PJM Manual 14B:

PJM Region Transmission Planning Process

Revision: ~~5152~~

Effective Date: ~~July 1, 2021~~ December 1, 2022

Exhibit 1: 24-Month Reliability Planning Cycle

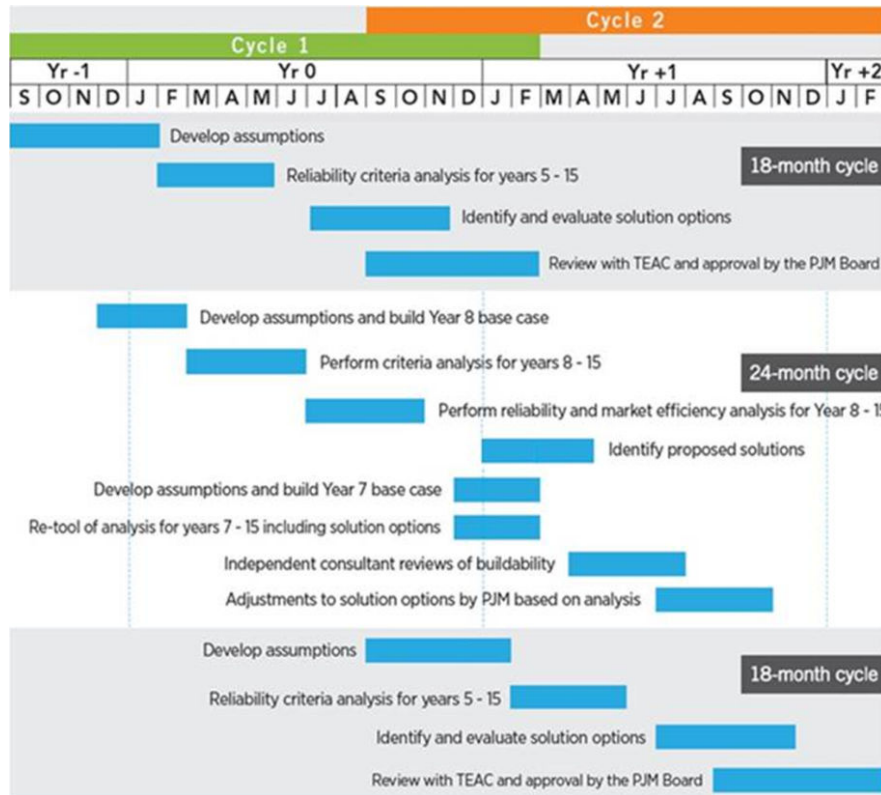
- **Changes to grammar in 1.3.2 Economic Planning**
- **Added a new subsection 1.4.2.4 Incorporation of EOL Needs into the RTEP**
- **Added new language detailing analysis in 2.1.2 Reliability Planning**
- **Added new graphics in 2.2.1 Reliability Planning**
- **Updated language to include Winter Peak Cases in 2.3.8 NERC P3 and P6 “N-1-1” Analysis**
- **Changed the title of subsection 2.3.15 to Extreme Event Review**
- **Added new objectives in 2.6 RTEP Market Efficiency Planning**
- **Added language in the following Attachments**
 - o **B.2 and B.3**
 - o **C.2.6**
 - o **D.1**
 - o **F**
 - o **G.9.2 and G.9.6**
 - o **H.1.2 and H.1.3**
